Order Instituting Rulemaking to Modernize
the Electric Grid for a High Distributed
Energy Resources Future.

Rulemaking 21-06-017

**PACIFIC GAS AND ELECTRIC COMPANY'S (U 39 E) OPENING COMMENTS
ON THE PUBLIC ADVOCATES OFFICES' 2025 DISTRIBUTION GRID
ELECTRIFICATION MODEL 2025 STUDY AND REPORT**

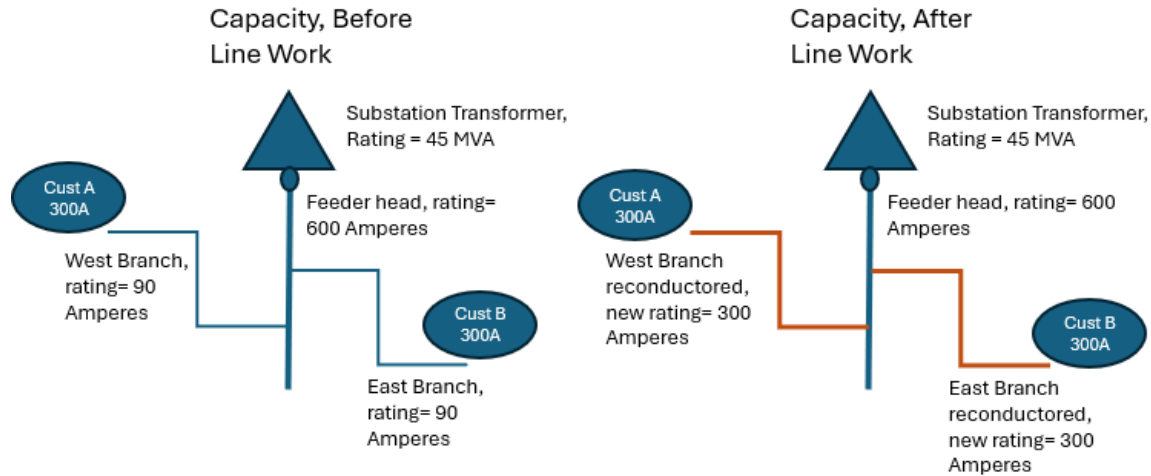
One solution in future iterations of the DGEM study would be to apply a multiplier to all primary distribution “feeder head upgrades” to estimate the cost of stand-alone distribution line section upgrades not associated with new feeders. These missing stand-alone line section upgrades represent a considerable portion of total distribution upgrades required to serve new load.

The reason why stand-alone line section upgrades are critical to customer energization can be seen below. These line section overloads are not seen when overloads are only assessed at the substation and feeder head. Mitigating these overloads does not add feeder head nor substation capacity.

Two line section reconductoring projects (East Branch and West Branch) are required to allow Customer A and Customer B to be energized, but neither project adds feeder head or bank capacity at the substation. Nor is the added capacity on one feeder branch additive to the capacity on the other feeder branch.
